February 7, 2025

**RE: The Reserve at Hockett Gulch Phase 1B and Phase 2 Major Development Permit
Response to Comments and Narrative of Changes**

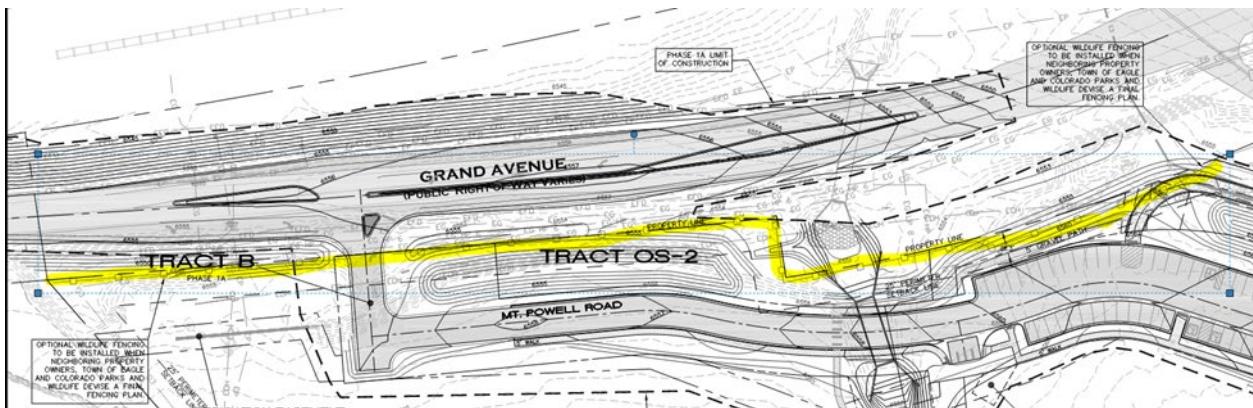
- Education. The WCP states construction employees and future residents should be educated on the sensitivity of wildlife harassment and best practice for preventing human-wildlife conflict in the area. The Landscape Plan includes "seasonal closure/wildlife advisory signage in the amenity schedule with quantity to TBD by contractor. Table notes state: "SIGNS SHALL BE CONSTRUCTED OF ALL-WEATHER MATERIALS AND POSTED IN HIGHLY VISIBLE LOCATIONS. LOCATIONS, DETAILS, AND INFORMATIONAL LANGUAGE OF SIGNS TO BE COORDINATED WITH AND APPROVED BY TOWN STAFF. The signs are proposed at the following locations:

- Signs proposed on the edge of the secluded seating area
 - By the dog park
 - By the Evergreen planting area
 - By the western crosswalk to OS-1 on Mt. Eve Road.

While finalizing signage approval through the Development Agreement is anticipated, there is information needed now to inform the final decision. As such, the seasonal closure/wildlife advisory signage and contractor notices need to be fleshed out within the WCP and documented throughout the applicable plan documents at this stage in the review process.

Response: The WCP identifies that seasonal closure and wildlife advisory signage is to be added. ("Additionally, contractors and residents should be notified of seasonal closures within the Town-owned Open Space through the use of temporary signage and notification by the Town of Eagle Open Space Coordinator.") The area which is to be seasonally closed is OS-1 and is being handled by Brian Lieberman, Open Space Coordinator at the Town of Eagle. The developer will work with the Town of Eagle to ensure signage is posted and these closures are enacted at the appropriate time.

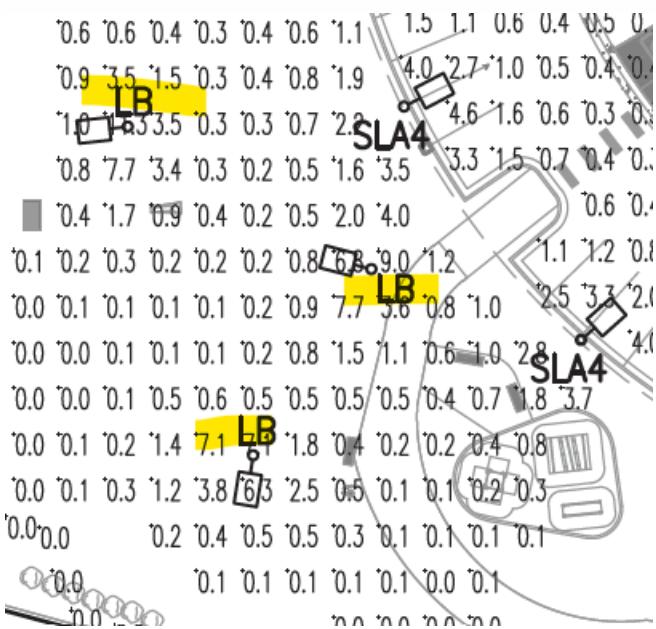
66. Show lighting outputs at all property lines.

67. Provide justification for installation of lighting and light levels along the gulch as it relates to the lighting recommendations in the Wildlife Conservation Plan.

68. Per the Wildlife Conservation Plan, town-owned property (OS-1) is a "naturalized vegetated buffer." Please explain how the recommendation to minimize nighttime lighting is being followed, particularly if the light source is visible beyond the property line.

69. An LB light fixture located by the 8,000 park within OS-1 appears to be on the town-owned property and outside the limit of work. Please confirm. (Repeat Comment).

70. One of the LB light fixtures located by the 8,000 park within OS-1 is not shown on the Landscape Plan. All plans within the MDP set must have consistent information.

Response: As discussed with Staff on February 3, 2025, the lighting plan comments will be addressed as a Condition of Approval. None of the below comments are of concern and will be addressed prior to building permit. Lighting plans have been removed from the architectural plans, with a note added to the plans stating their deferment as a condition of approval.
